ADDENDUM No. 7
TO
CITY OF FRESNO
PUBLIC WORKS STANDARD SPECIFICATIONS
ADOPTED MARCH 4, 1970
RESOLUTION NO. 70-36
UPDATED VERSION APPROVED: DECEMBER 2020 (tentative)
ADMINISTRATIVE DRAFT
for industry review and comment

This addendum is attached to, and made a part of, the above-entitled standard specifications.

The following City Standard Drawings have been amended as indicated below:

CITY OF FRESNO
RW-7

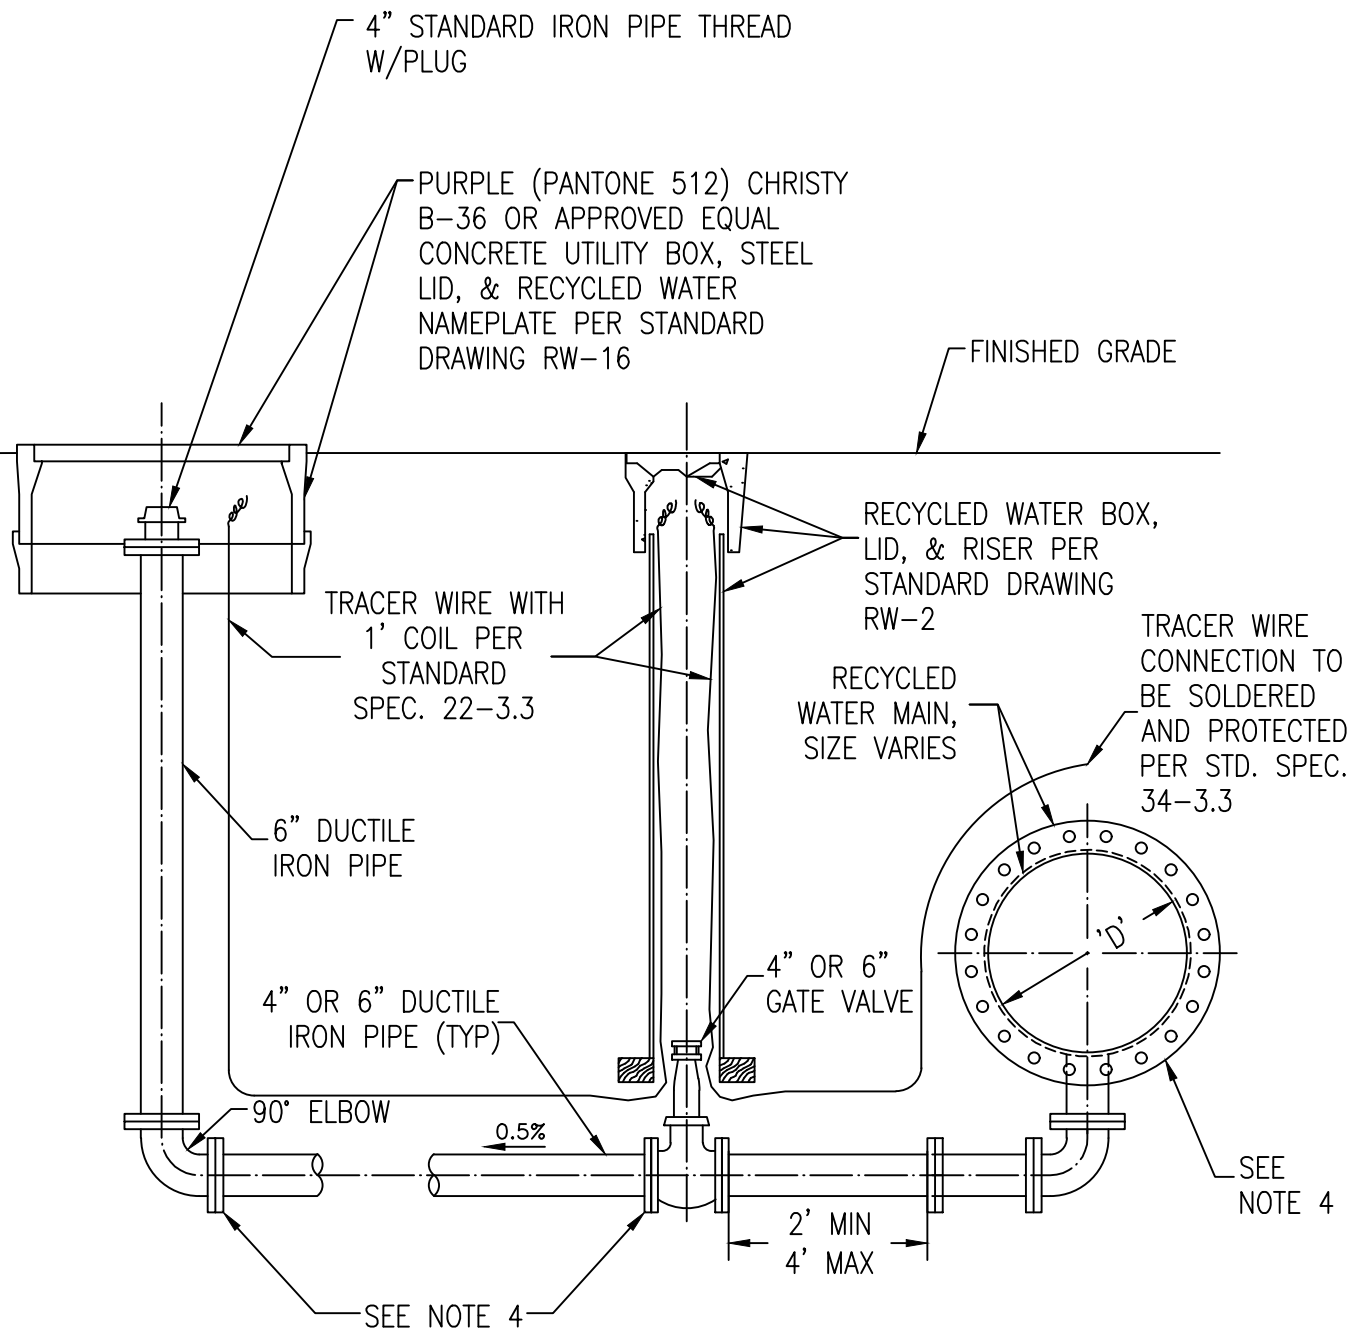
RW-7	<ol style="list-style-type: none"> Callout: "PURPLE (PANTONE 512) CHRISTY METER BOX WITH LID (17" X 30") AND MARKED WITH THE WORDS "RECYCLED WATER"" Revised to read: "PURPLE (PANTONE 512) CHRISTY B-36 OR APPROVED EQUAL CONCRETE BOX, STEEL LID AND RECYCLED WATER NAME PLATE PER STANDARD DRAWING RW-16" Callout: "2" x REQUIRED LENGTH GALVANIZED STEEL PIPE TYPE "K" RIGID OR SOFT, CONTINUOUSLY WRAPPED WITH APPROVED PURPLE RECYCLED WATER MARKING TAPE" Revised to read: "2" x REQUIRED LENGTH GALVANIZED STEEL PIPE, CONTINUOUSLY WRAPPED WITH APPROVED PURPLE RECYCLED WATER MARKING TAPE" Callout: "TRACER WIRE WITH 1' COIL PER STANDARD SPEC. 22-3.3" Revised to read: "TRACER WIRE WITH 1' COIL PER STANDARD SPEC. 34-3.3" Note 3: "RESTRAIN ALL JOINTS PER SITY STANDARD SPECIFICATIONS SECTION 21-15.5" Revised to

read, "RESTRAIN ALL JOINTS PER SITY STANDARD SPECIFICATIONS SECTION 33-14.5"
RW-8	1. Drawing split and renamed, "RW-8A" and "RW-8B". Technical changes shown for RW-8A, below, apply to both.
RW-8A	<ol style="list-style-type: none"> 1. Drawing title, "RECYCLED WATER BLOW-OFF ASSEMBLY" Revised to read: "RECYCLED WATER BLOW-OFF ASSEMBLY (PVC OR DUCTILE IRON MAIN)" 2. Callout, "2-1/2" STANDARD MALE FIRE HOSE THREADED CONNECTION WITH CAP & RECYCLED WATER IDENTIFICATION TAG PER STANDARD DRAWING RW-18" Revised to read: "4" STANDARD IRON PIPE THREAD W/PLUG". 3. Drawing Revised: Blow-off connection to main changed from 45° ELL to 90° ELL at bottom of pipe. 4. Note 4: "RESTRAIN ALL JOINTS PER SITY STANDARD SPECIFICATIONS SECTION 21-15.5" Revised to read, "RESTRAIN ALL JOINTS PER SITY STANDARD SPECIFICATIONS SECTION 33-14.5" 5. Callout: "TRACER WIRE CONNECTION TO BE SOLDERED PER STD. SPEC. 34-3.3" Revised to read, "TRACER WIRE CONNECTION TO BE PROTECTED AND SOLDERED PER STD. SPEC. 34-3.3" 6. Tracer wire relocated to inside the riser barrel.

**CITY OF FRESNO
RW-8B**

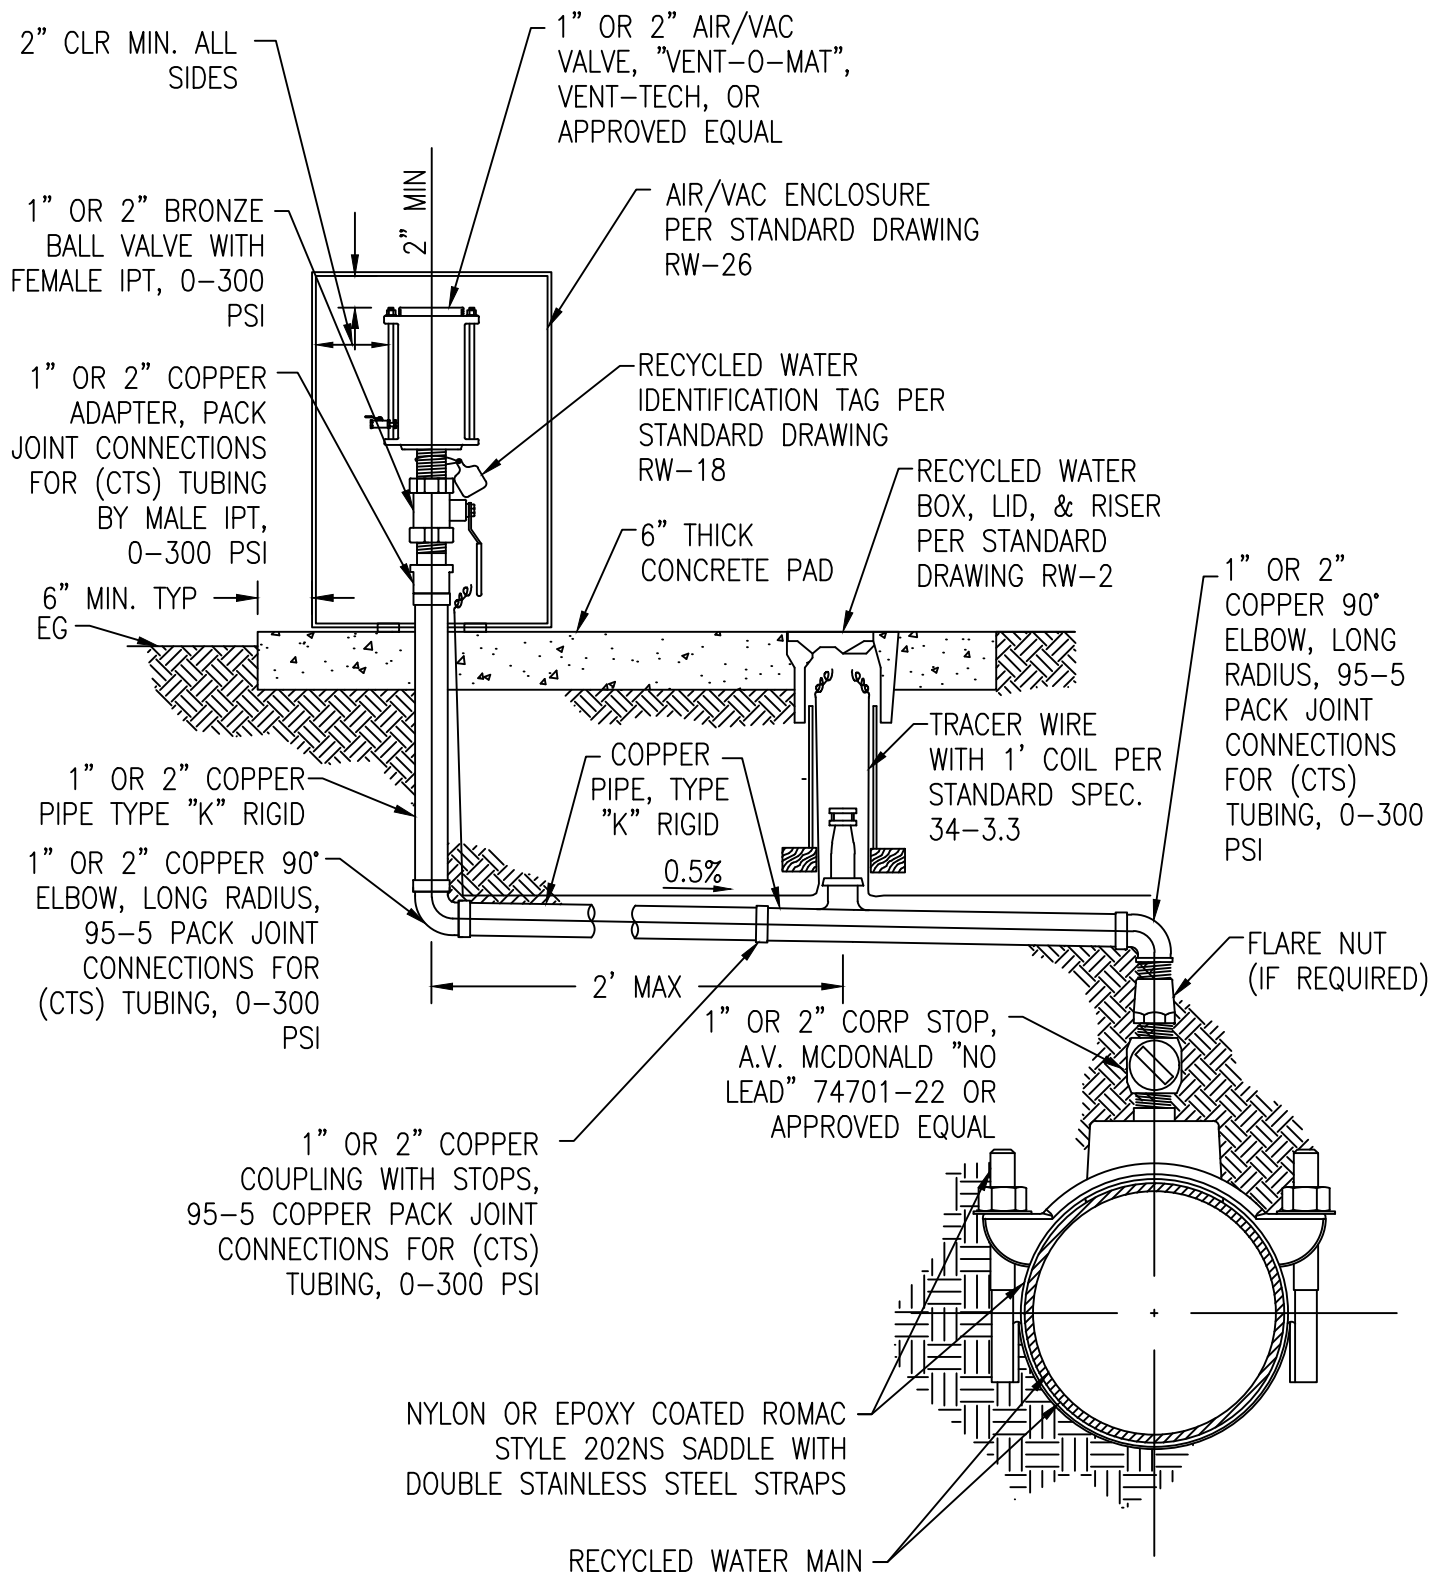
RW-8B	1. New Standard Drawing: "RECYCLED WATER BLOW-OFF ASSEMBLY (STEEL MAIN)"
RW-9	<ol style="list-style-type: none"> 1. Drawing title: "RECYCLED WATER 1" OR 2" AIR RELEASE/VACUUM BREAKER STATION" Revised to read, "RECYCLED WATER 1" OR 2" AIR RELEASE/VACUUM BREAKER ASSEMBLY" 2. Callout(s), "1" OR 2" COPPER 90° ELBOW, LONG RADIUS, 95-5 SOLDER JOINTS, 0-300 PSI" Revised to read: "1" OR 2" COPPER 90° ELBOW, LONG RADIUS, 95-5 PACK JOINT CONNECTIONS FOR (CTS) TUBING, 0-300 PSI" 3. Callout, "1" OR 2" COPPER COUPLING WITH STOPS, 95-5 COPPER SOLDER JOINTS, 0-300 PSI" Revised to read: "1" OR 2" COPPER COUPLING WITH STOPS, 95-5 PACK JOINT CONNECTIONS FOR (CTS) TUBING, 0-300 PSI" 4. Callout, "1" OR 2" COPPER ADAPTER, SOLDER JOINT BY MALE IPT, 0-300 PSI" Revised to read: "1" OR 2" COPPER ADAPTER, PACK JOINT CONNECTIONS FOR (CTS) TUBING, 0-300 PSI" 5. Callout, "TRACER WIRE WITH 1' COIL, PER STANDARD SPEC. 22-3.3" Revised to read: "TRACER WIRE WITH 1' COIL PER STANDARD SPEC. 34-3.3" 6. Callout, "AIR/VAC ENCLOSURE PER STANDARD DRAWING RW-11" Revised to read: "AIR/VAC ENCLOSURE PER STANDARD DRAWING RW-26" 7. Callout added: "RECYCLED WATER BOX, LID, & RISER PER STANDARD DRAWING RW-2" 8. Drawing Revised: limits of concrete pad expanded to incorporate water valve. 9. Drawing Revised: water valve added to drawing. 10. Removed dimension: "2' MIN" (located between saddle tap and copper coupling) 11. Added dimension: "2' MAX" (located between water valve and air/vac valve) 12. Note 3: "RESTRAIN ALL JOINTS PER SITY STANDARD SPECIFICATIONS SECTION 21-15.5" Revised to read, "RESTRAIN ALL JOINTS PER SITY STANDARD SPECIFICATIONS SECTION 33-14.5" 13. Tracer wire relocated to inside the riser barrel.
